PLAN: East Boston Public Comments

**as of 12/1/23*

Table of Contents:

Approximate existing dimensions of Border Street

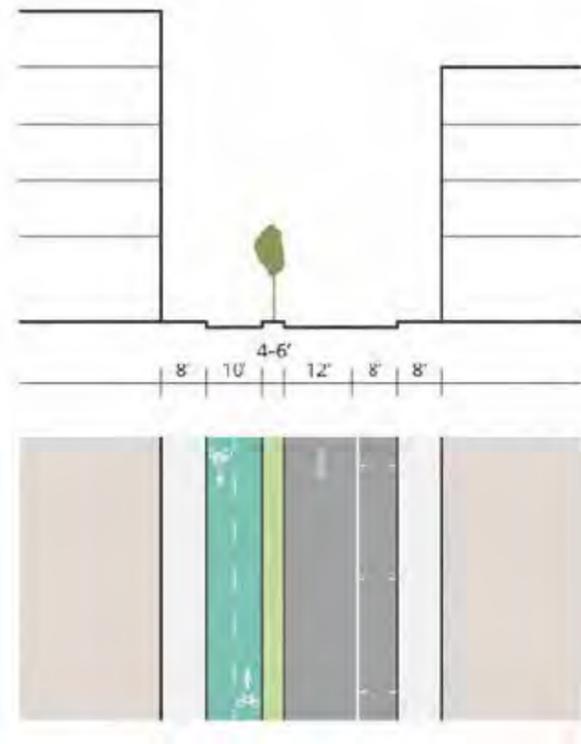
Border Street is a half-mile long between Saratoga and Condor. There are *no traffic lights, no stop signs, and only five pedestrian cross-walks*—all at vehicular entry/exit locations on the west side, but not at the two most crucial and dangerous locations at the shopping center. There are two areas of Border Street with no pedestrian cross-walks for stretches of eight hundred feet.

Consequently, BORDER STREET HAS BECOME A “CUT-THROUGH” STREET, even though it is a local street, not a connector. Todisco Tow trucks from Condor Street, for example, use it instead of Meridian Street because Meridian Street has frequent cross streets, traffic lights, buses, and bus stops, all of which act as “traffic calming” agents. Border Street has none of this, making it a cut-through alternative to Meridian Street.

When the bridge to Chelsea is up, outbound traffic backs up well down the east side of Border Street and Meridian Street, and when school is out around 2:00 pm, inbound child pick-up traffic lines up along the west side of Border Street, making a one-way street impossible.

Proposed Street Design, 1 in. = 16'

Dimensions vary slightly along Border Street. An accurate survey is necessary in order to make a definitive design for the street.

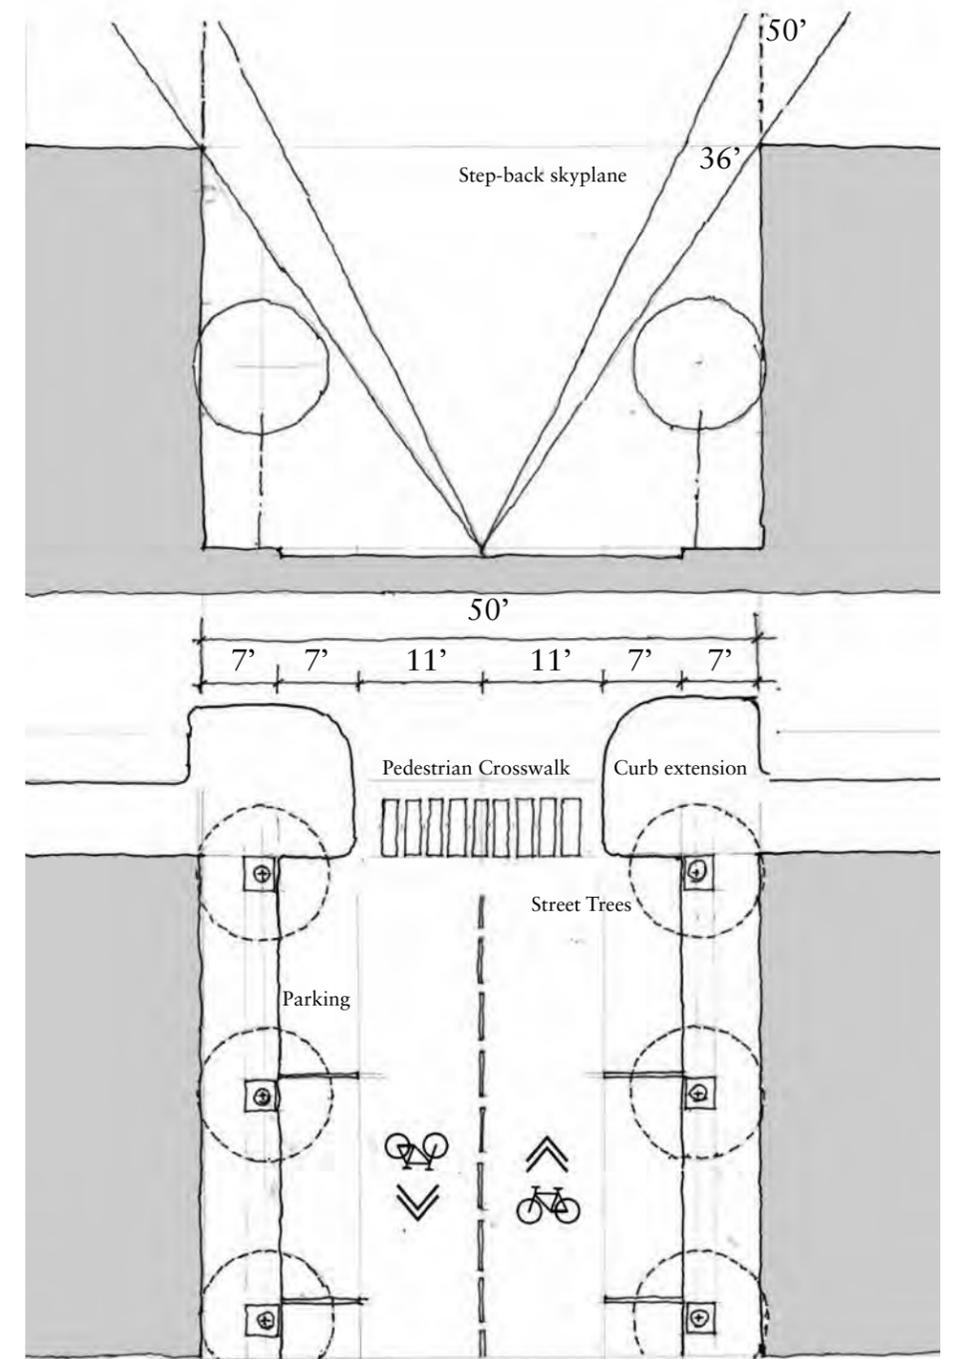
In general, the height of urban street walls should be at least equal to the width of the street, i.e., a 1:1 ratio, and up to 1:1.5.

East side parcels should be approximately 25' with no project wider than two to three parcels.
